Access Compliance Report

Public Rights-of-Way

(Curb Ramps)

Intersection ID: 11322	Main Street: N_GRAHAM_ST	Cross Street: W_10TH_ST	Location: S
ADA ID: D28E159C1B3E	Ramp Type: Perp	Initial Pass/Fail: Fail	Overall Compliance: No
Severity Score: 13.75			
Codes/Mitigation Info/Possible Solution		Field Measurements/Component Compliance

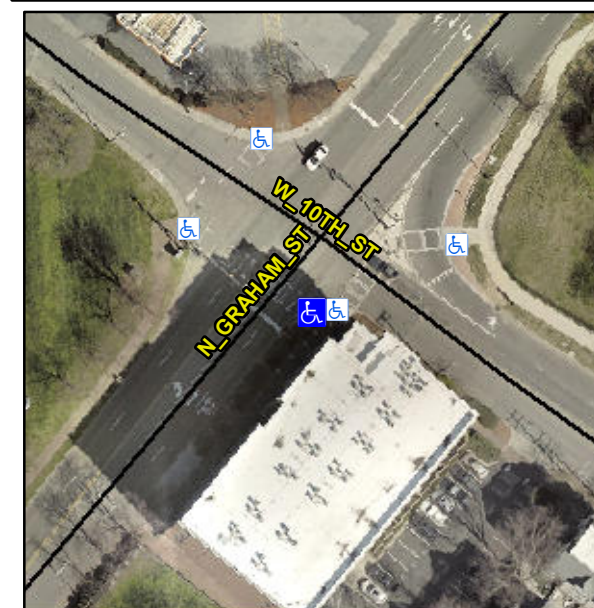
Not Found, R304.2.2, R304.5.3

Compliance	Description	Data	Compliance	Description	Data
N/A	Ramp Length (in)	70.0	No	Ramp Slope (%)	9.0
Yes	Ramp Width (in)	48.0	No	Ramp XSlope (%)	4.8
N/A	Flare Type LT	N/A	N/A	Flare Type RT	N/A
N/A	Flare Slope LT (%)	N/A	N/A	Flare Slope RT (%)	N/A
N/A	Flare Traversable LT?	N/A	N/A	Flare Traversable RT?	N/A
N/A	Landing Length (in)	N/A	N/A	DWS Provided?	N/A
N/A	Landing Width (in)	N/A	N/A	DWS Contrast?	N/A
N/A	Landing Slope (%)	N/A	N/A	DWS Length (in)	N/A
N/A	Landing X Slope (%)	N/A	N/A	DWS Full Width?	N/A
N/A	Landing Curb? (Y/N)	N/A	N/A	DWS Offset (in)	N/A
N/A	Shared Landing?	N/A			
N/A	Gutter Ponding?	N/A	N/A	Gutter Slope (%)	N/A
N/A	Gutter Lip Ht (in)	N/A	N/A	Gutter X Slope (%)	N/A
N/A	Painted X Walk1?	Yes	N/A	Painted X Walk2?	N/A
	X Walk 1 Direction	To NW		X Walk 2 Direction	N/A
N/A	X Walk 1 Width (in)	112.0	N/A	X Walk 2 Width (in)	N/A
	X Walk 1 Slope (%)	2.1		X Walk 2 Slope (%)	N/A
	X Walk 1 X Slope (%)	0.2		X Walk 2 X Slope (%)	N/A

Remove & Replace Entire Ramp.
